1. AGENCY USE ONLY (Leave blank)			2. REPORT DATE 11/00/90	3. REPORT TYPE AND DATES COVERED
4. TITLE AND SUBTITLE EXPLANATION OF DIFFERENCES FOR BASIN F LIQUIDS, IRA DECISION DOCUMENT, DRAFT, VERSION 2.0			5. FUNDING NUMBERS DAAA15 88 D 0022

DRAFT
EXPLANATION OF DIFFERENCES
FOR
BASIN F LIQUIDS
IRA DECISION DOCUMENT

VERSION 2.0
NOVEMBER 1990
CONTRACT NO. DAAA15-88-D-0022/0001

CONCEPTUAL DESIGN OF SUBMERGED
QUENCH INCINERATION WITH
SPRAY DRYING

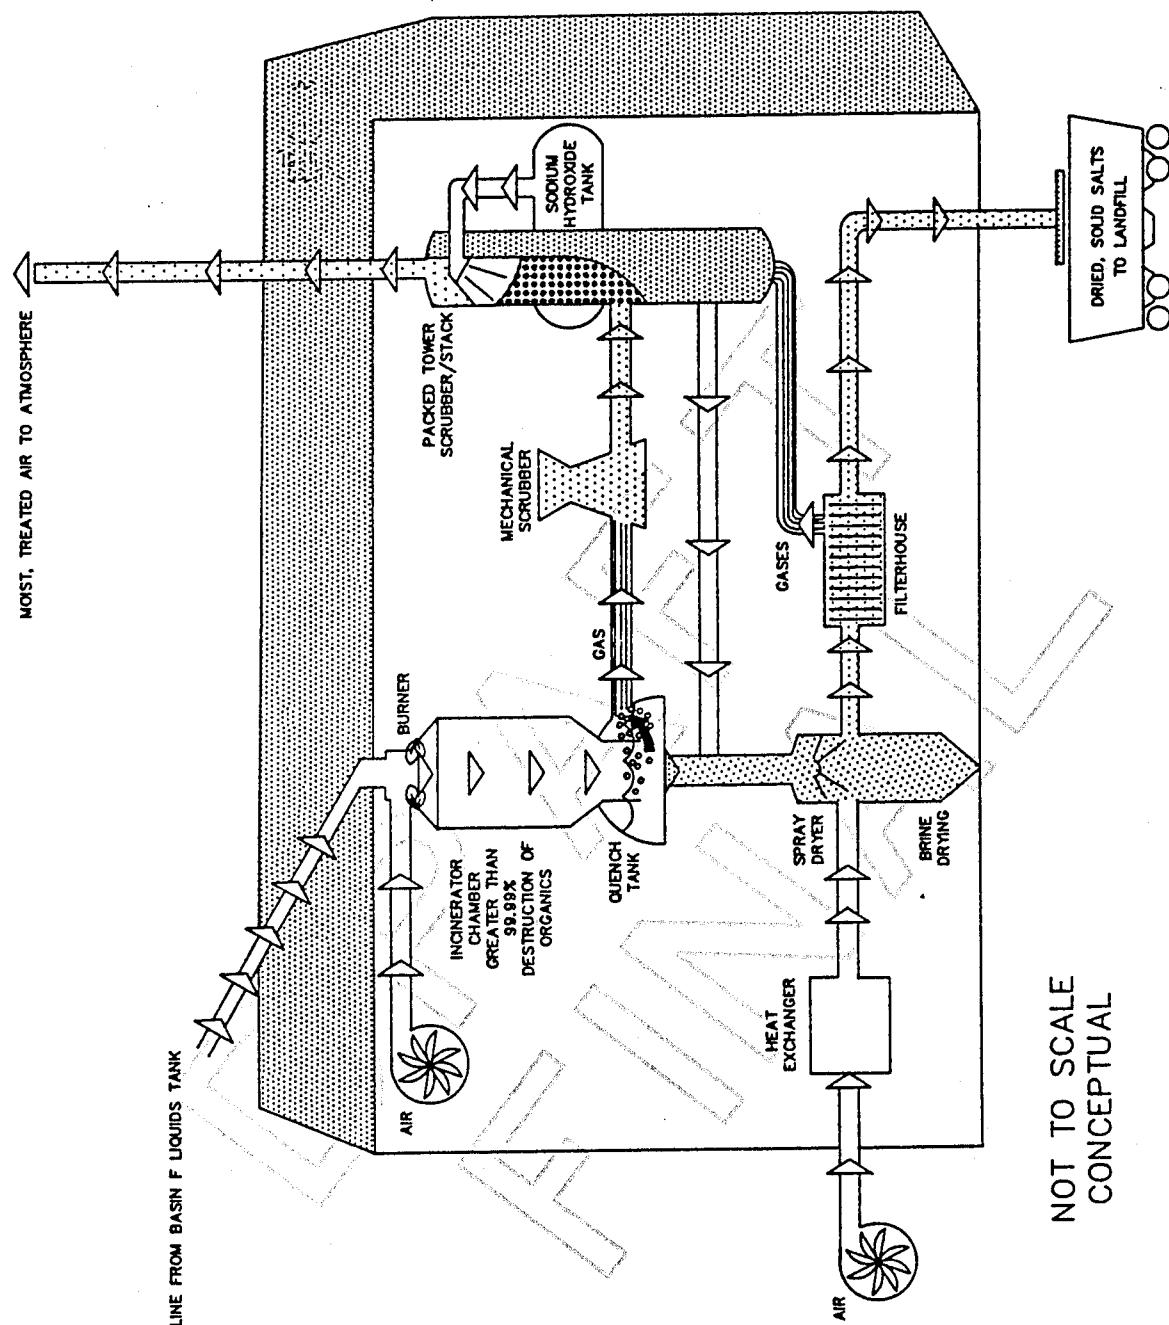
In the Decision Document the conceptual design included a Submerged Quench Incineration and spray dryer treatment that resulted in a dry residual salt. The total treatment system consists of a waste feed system, an incineration system, air pollution control equipment, a spray dryer, and a residuals handling system. Figure 1 is a conceptual schematic of the total treatment system as selected in the Final Decision Document.

- Elimination of the spray dryer from the design and all ancillary equipment associated with the operation of the spray dryer. (Baghouse, salt transfer system, salt storage vessels, and salt loading equipment). The elimination of the spray dryer equipment will also eliminate the need for offsite shipment and landfill disposal of the dried salt product.

CONCEPTUAL DESIGN OF
SUBMERGED QUENCH
INCINERATION

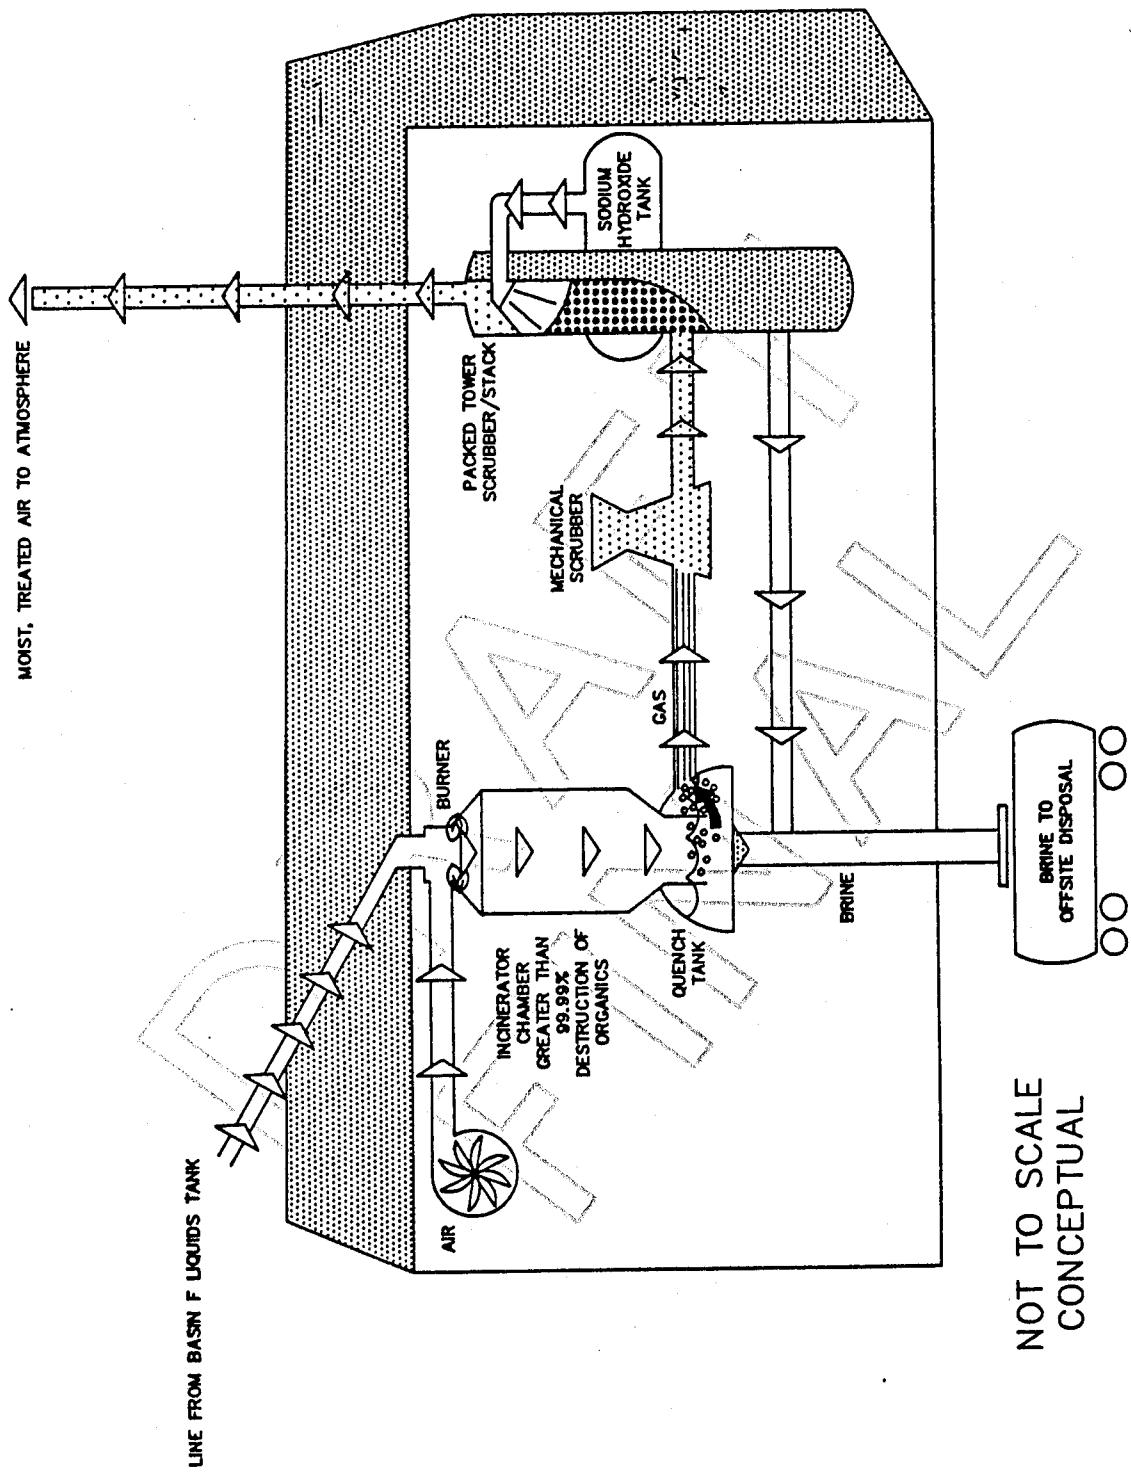
The major differences between the remedial action described in the May 1990 Decision Document and the currently intended remedial action are in the area of incinerator brine management. The brine is an aqueous solution that contains approximately 25-35% salt, 65-75% water, and low levels of heavy metals (primarily copper). An approximate composition of the incinerator product brine appears in Table 1. The currently intended remedial action will involve offsite shipment, treatment, and disposal of the brine with no additional onsite processing (spray drying) (see Figure 2). The specific differences between the current and the original remedial action are as follows:

- The residual brine will be shipped in bulk form by rail to a licensed treatment, storage, and disposal facility for further treatment, metal removal or recovery, and disposal. Two commercial facilities have committed to accept the brine.

- The intended remedy will offer additional treatment of the brine at the Treatment, Storage or Disposal Facility (TSDF). This treatment will include metals removal/recovery which will reduce or eliminate the volume of waste which will ultimately be landfilled and reduce its mobility and potential long term environmental impact.
- It is important to recognize that the May 1990 remedial action and the intended remedial action remain fundamentally the same. The only differences are in the management of the residual brine.

Most of the elements of the preferred remedial action for Basin F Liquid have not changed in this intended modification. The system will consist of a waste feed system, incineration system and air pollution control equipment. The components that will be changed are the spray dryer and solids handling system. The residual brine will be pumped from the SQI to one of two holding tanks. The brine will then be pumped from the holding tanks to railcars for shipment to an offsite treatment plant. The railroad siding area will increase above what was planned for the spray drying system in order to accommodate enough railcars for offsite brine disposal.
